UNITED STATES PATENT AND TRADEMARK OFFICE

APPLICATION NO.	FILING DATE	FIRST NAMED INVENTOR	ATTORNEY DOCKET NO.	CONFIRMATION NO.
10/710,787	08/03/2004	Alexander Stoll	81101892 / FMC 1771 PUS	4786

Office Action Summary	Application No. 10/710,787	Applicant(s) STOLL ET AL.	
	Examiner Dana Ross	Art Unit 3722

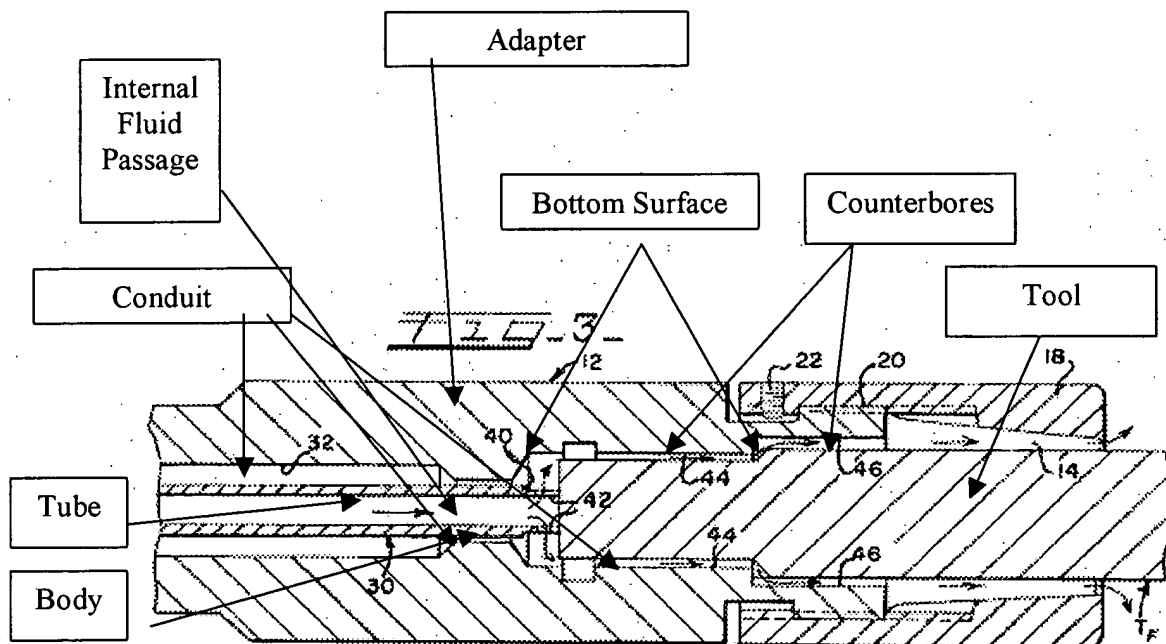
7. Claims 1, 2, 4-9, 11-13 and 16-18, as best understood, are rejected under 35 U.S.C. 102(b) as being anticipated by US Pat. No. 4,640,652 (Rivera, Jr., hereafter ‘652).

‘654 teaches a tool holder for coolant deliver with a plurality of bores and a bottom surface, a conduit with first and second diameters and internal fluid passage (see figure 3 below) and spring 34 (see figure 2); the connection tube with a section with a smaller outside diameter than another section of the tube (see figure 3 below) with the inside of the tube engaging with the

internal fluid passage. It is noted that '652 teaches a chamfer on a flange portion (see figure 1, for example).

Regarding the spring, '652 teaches spring 34 meets which the limitation requirements of claims 5 and 8 in that the tool receiving portion the end portion (see area 26 of figure 2) which places the spring 34 between the "tool receiving portion" and the "bottom surface" (see figures 2 and 3).

Regarding the chamfer, '652 teaches a chamfered area of the internal fluid passage (see figure 2 near reference number 36).
